DAVE BAXTER  
Vice President  
Oconee Nuclear Station

Subject: Duke Energy Carolinas, LLC  
Oconee Nuclear Site, Units 1, 2, and 3  
Docket Numbers 50-269, 50-270, and 50-287  
Requests for Additional Information for Proposed License Amendment Request to Revise  
the Technical Specifications for AREVA NP Mark-B-HTP Fuel and for Methodology  
Report DPC-NE-2015-P "Mark-B-HTP Fuel Transition Methodology"  
License Amendment Request No. 2007-12

**DPC-NE-2015-P, REVISION 0**

**RESPONSES TO NRC REQUEST FOR INFORMATION**

Figure 6-1 RPS Core Protection Safety Limits

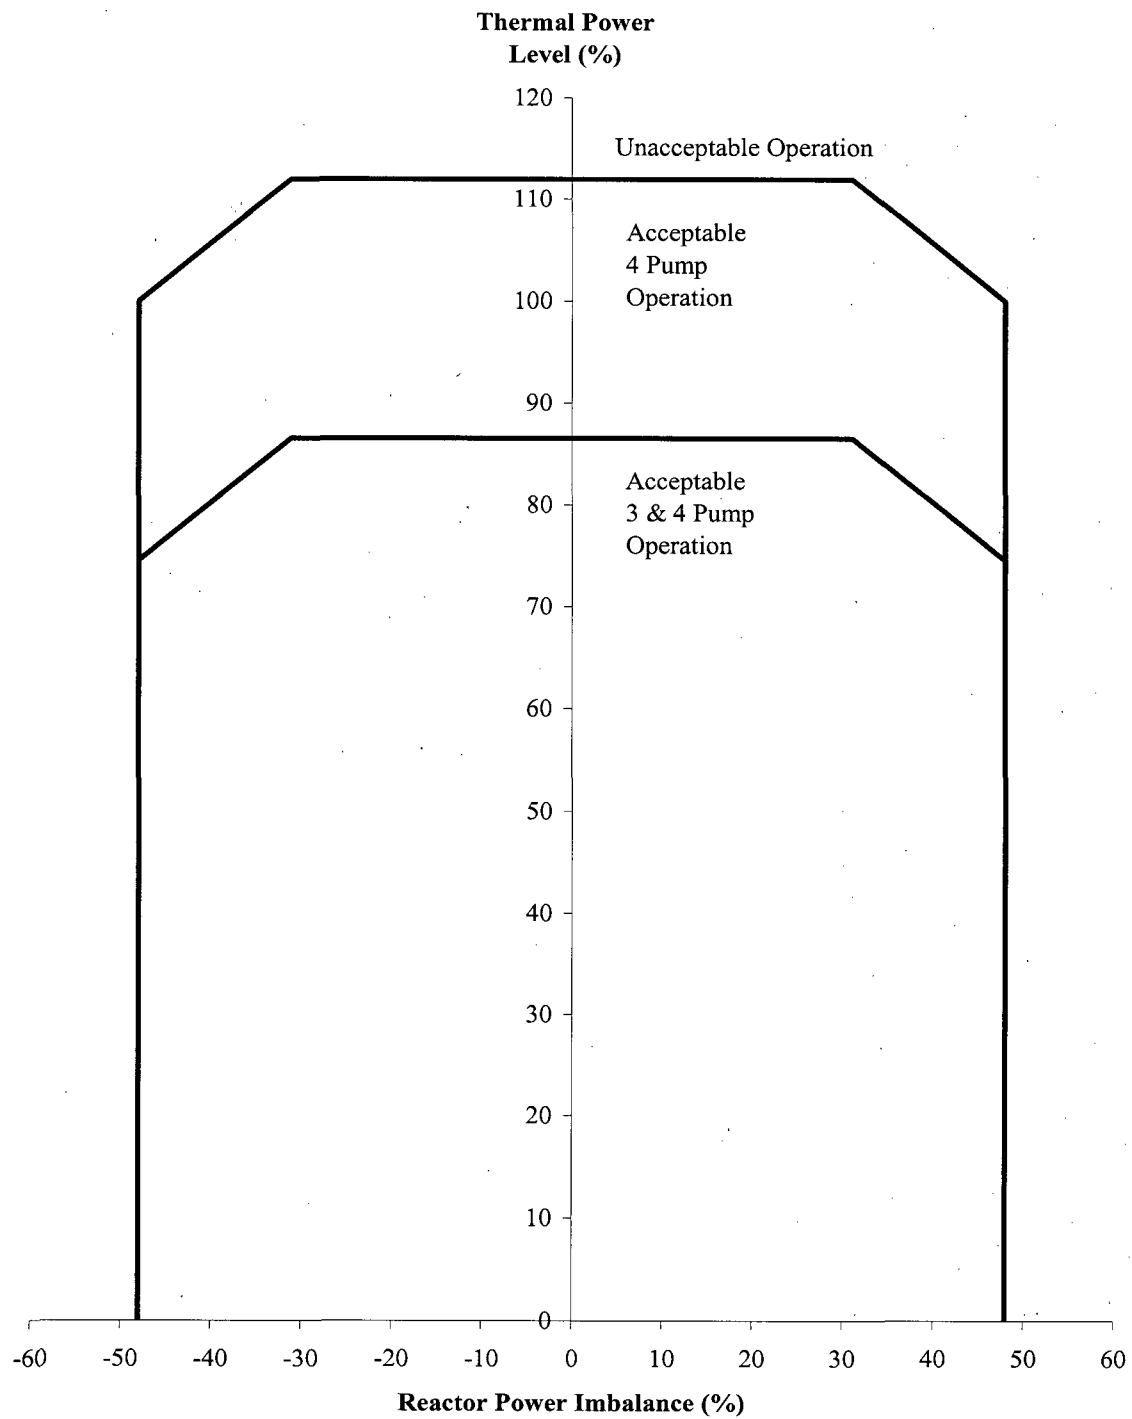
Provide the revised Figure 6-1 in DPC-NE-2003P-A in Revision 6-7.

The revised Figure 6-1, with the [ ] limit line removed, is presented on the following page. The data points in the figure are shown in the table below.
